Informal Request for Further Information Regarding the Eight Notices of Requirement for Warkworth by Auckland Transport

**Table 1 – Information Requested
Notices of Requirement - NoR 1 – NoR 8 – Warkworth**

Re: Response to further information request for the Warkworth Package

Response to Request for Further Information

**Site: 101 [Matakana Link Road - Western Link Road_AM]**

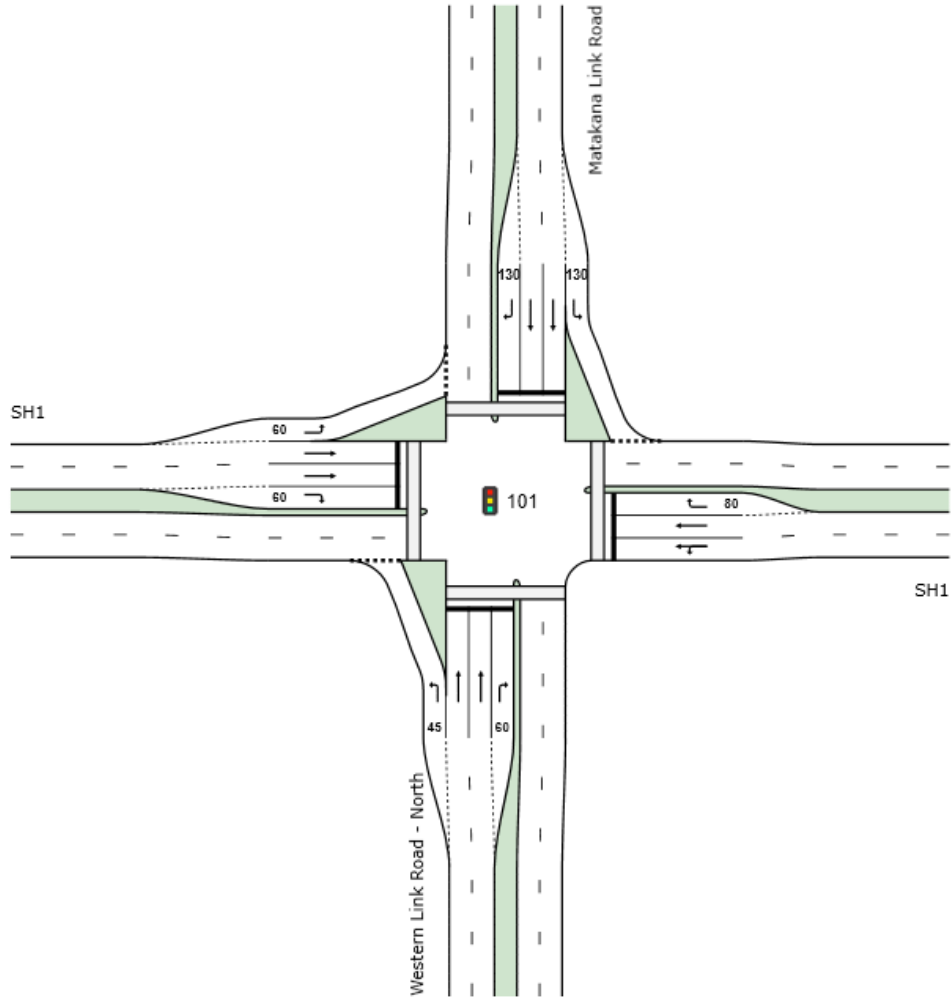
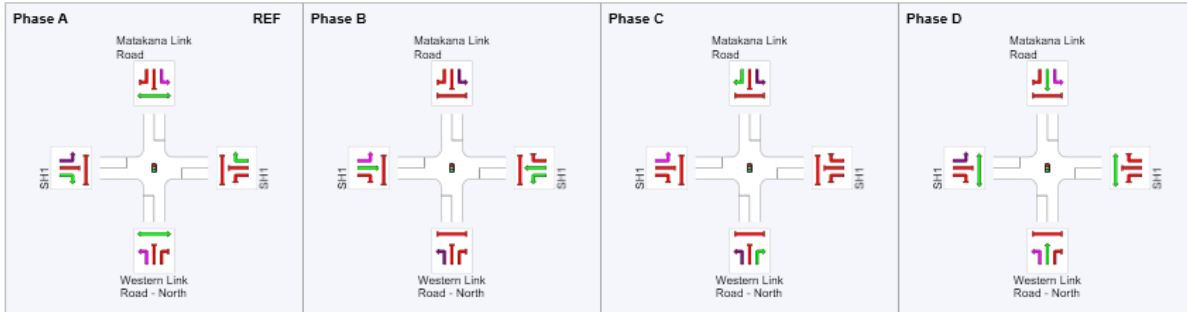
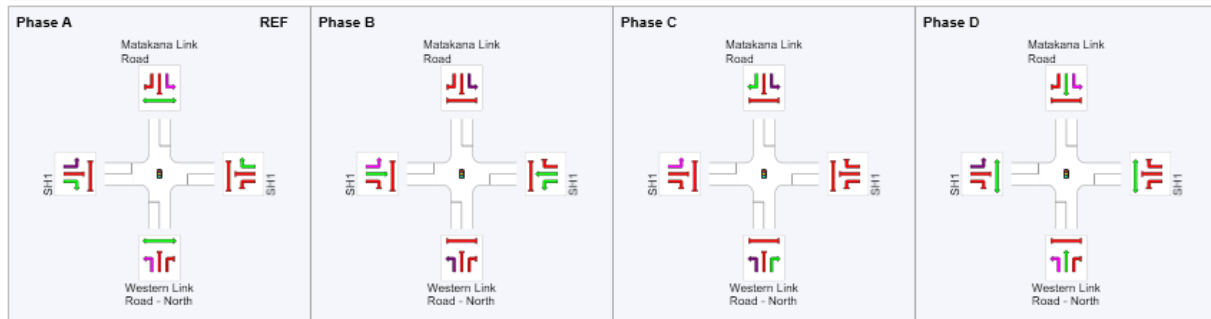
TR12.		Assessment of Transport Effects Appendix 3 - Traffic Modelling		Please provide further modelling output in the form of SIDRA Model layouts, modelled traffic signal phasing (where applicable) and Summary Lane Outputs should be provided.	Summary SIDRA modelling output has been provided in Appendix 3. To assist in reviewing the modelling output the SIDRA Model layouts, modelled traffic signal phasing (where applicable) and Summary Lane Outputs should be provided.	<i>The requested SIDRA files have been provided. However, it is noted that these intersection models have been developed to inform the indicative footprint for key arterial intersections on the Warkworth network. The actual intersection form and layout is expected to be reviewed in the future when greater certainty is available. It is noted that this is covered in the UDLMP where the intersection form will be confirmed as part of the concept design.</i>
